## Certificate of Appropriateness Case Report

HEARING DATE: JUNE 20, 2012

*Filing Date:* December 14, 2011  
*Case No.:* **2011.1391A**  
*Project Address:* **260 GREEN STREET**  
*Historic Landmark:* Telegraph Hill Historic District  
*Zoning:* RH-3 (Residential, House, Three-Family) District  
40-X Height and Bulk District  
*Block/Lot:* 0113/042  
*Applicant:* Daniel Frattin  
Reuben & Junius, LLP  
One Bush Street, Suite 600  
San Francisco, CA 94104  
*Staff Contact:* Pilar LaValley - (415) 575-9084  
pilar.lavalley@sfgov.org  
*Reviewed By:* Tim Frye - (415) 575-6822  
tim.frye@sfgov.org

1 PROPOSED SOUTH ELEVATION - REVISION 2  
1/4" = 1'-0"

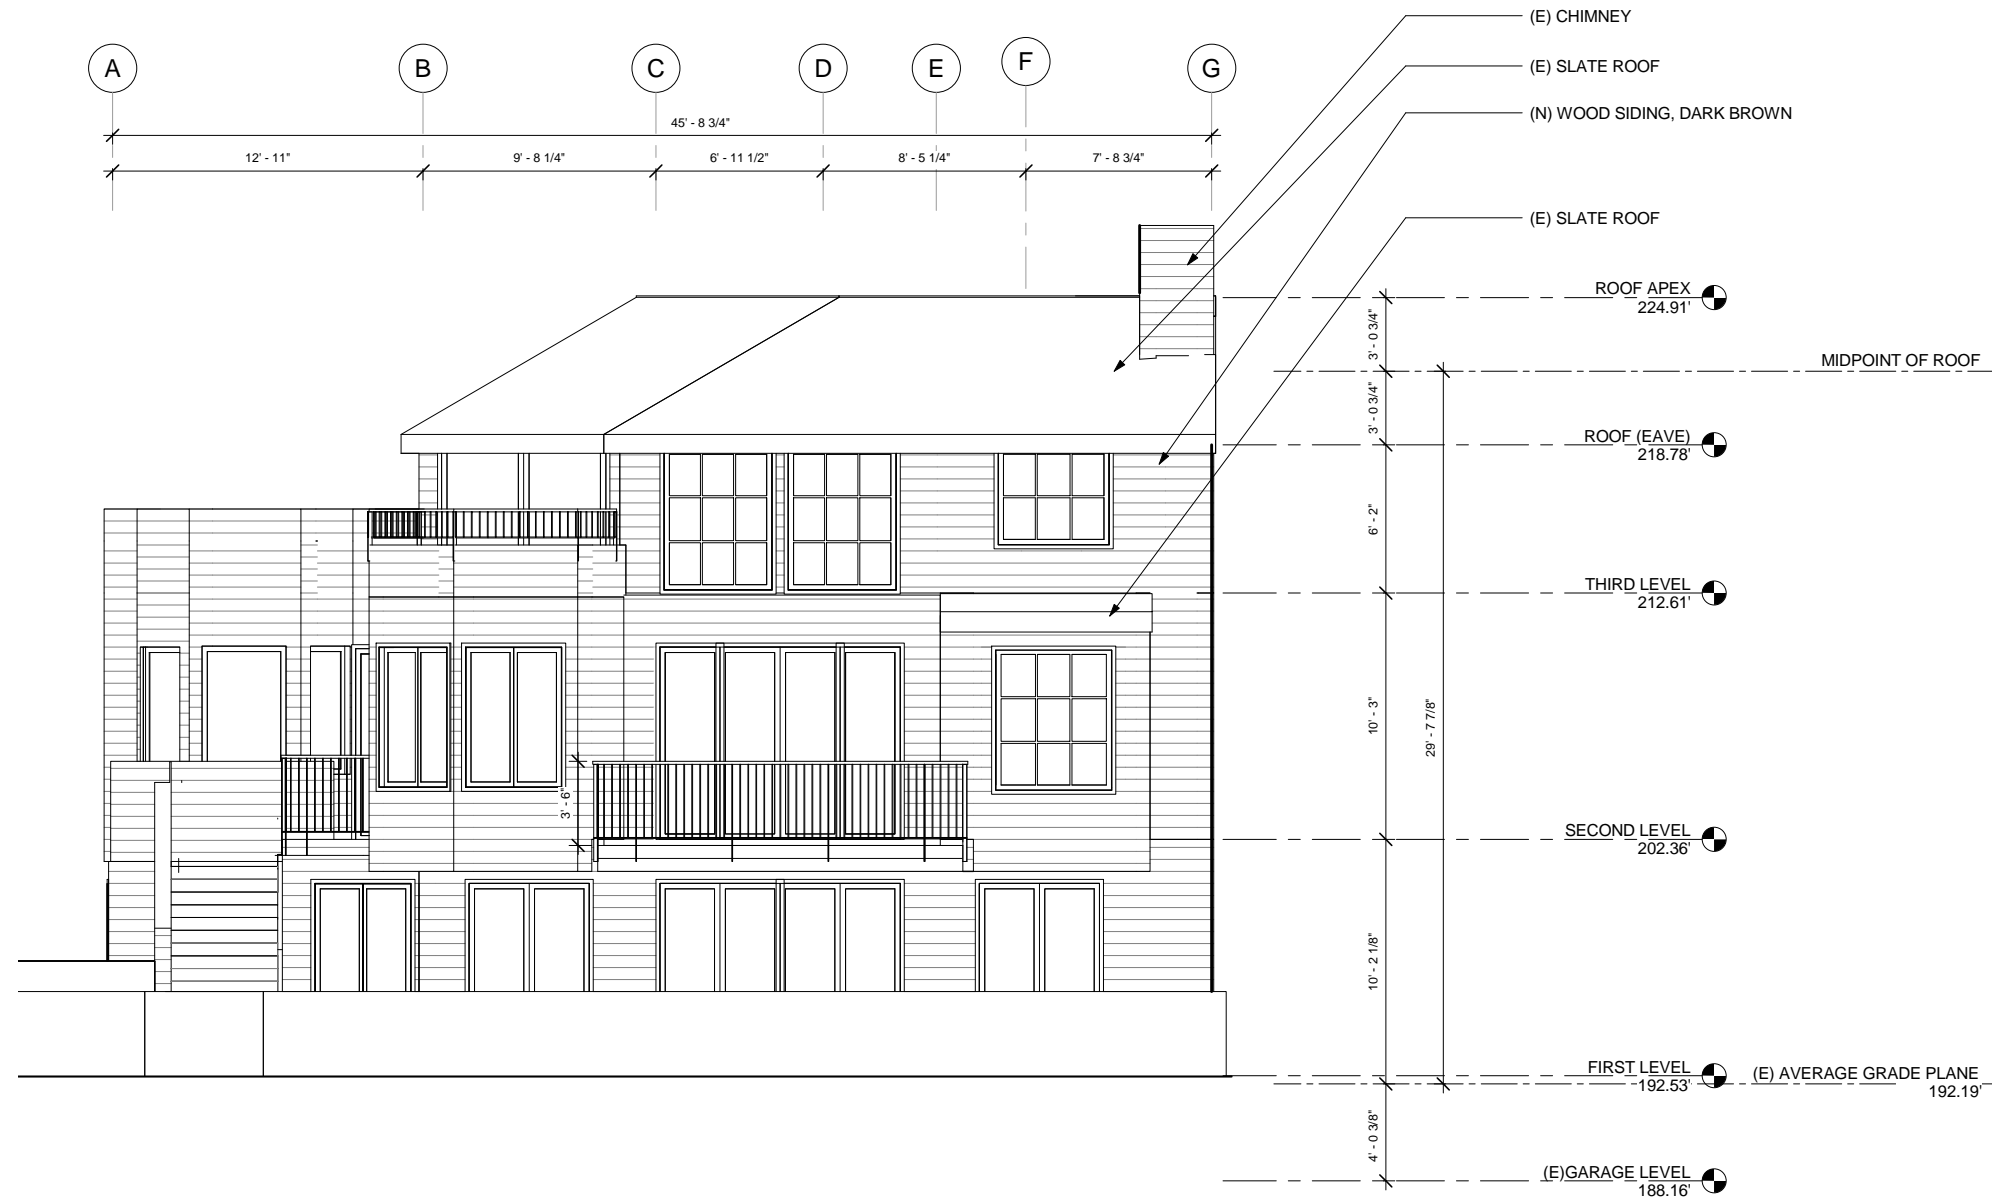
- a. 3<sup>rd</sup> Floor East windows at Master Bedroom - reduced in size
  - b. 3<sup>rd</sup> Floor East/South deck guardrail @ Master Bedroom – solid wall retained; wood pickets added on top

- c. South entry stair guardrail material – wood siding
  - d. 3<sup>rd</sup> Floor South window above entry door @ Master Bathroom – reduced in size
21. 05/29/2012: Revised Elevations sent to Planning

- a. **Design revised to comply with suggestions.**
22. 06/08/2012: Revised Elevations sent to Telegraph Hill Dwellers
23. 06/20/2012: HPC Hearing
